# Cub Cadet

Code No.: CC-148

Date: DECEMBER 2, 1987

Subject: INCORRECT DIPSTICKS ON GARDEN TRACTORS

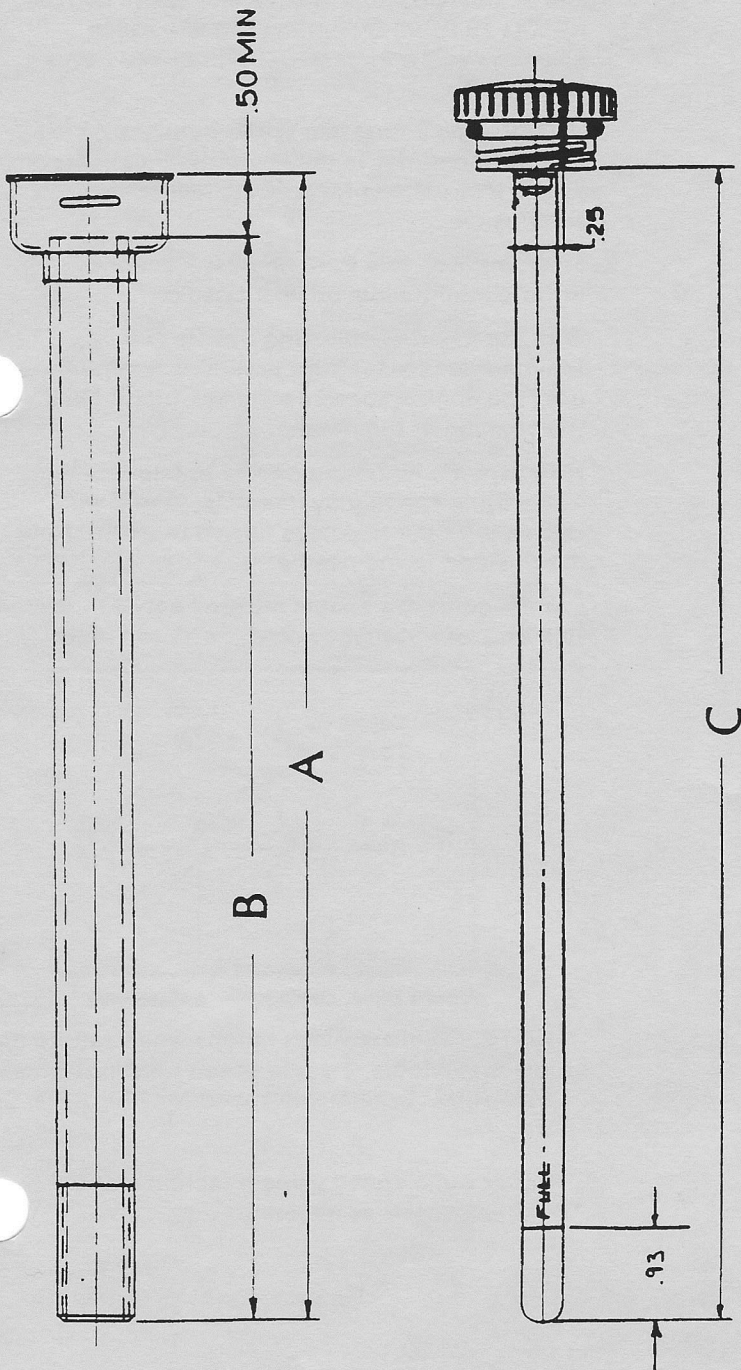
If the transmission oil level is incorrect on a new garden tractor, verify that the tractor has the correct dipstick and tube before adding oil.

HOOD LABEL	FACTORY NO.	OLD CCC NUMBER	TUBE NO.	TUBE DEM. A	TUBE DEM. B	DIPSTICK NO.	DIPSTICK DEM. C
1806	147-640-100	1606, 582	727-3028	9.25"	8.75"	703-0921	12.75"
1210	147-620-100	680	727-3028	9.25"	8.75"	703-0911	11.50"
1211	147-630-100		727-3028	9.25"	8.75"	703-0911	11.50"
1810	147-650-100	682, 782, 1710	727-3028	9.25"	8.75"	703-0911	11.50"
1811	147-660-100	782, 1711	727-3028	9.25"	8.75"	703-0911	11.50"
1812	147-670-100	784, 1712	727-3028	9.25"	8.75"	703-0911	11.50"
1512	147-882-100	882	727-3028	9.25"	8.75"	703-0911	11.50"
1572	147-710-100		727-3042	10.75"	10.25"	703-1496	12.00"
1872	147-720-100		727-3029	10.25"	9.75"	703-0911	11.50"
2072	147-730-100	982, 984, 986	727-3029	10.25"	9.75"	703-0911	11.50"
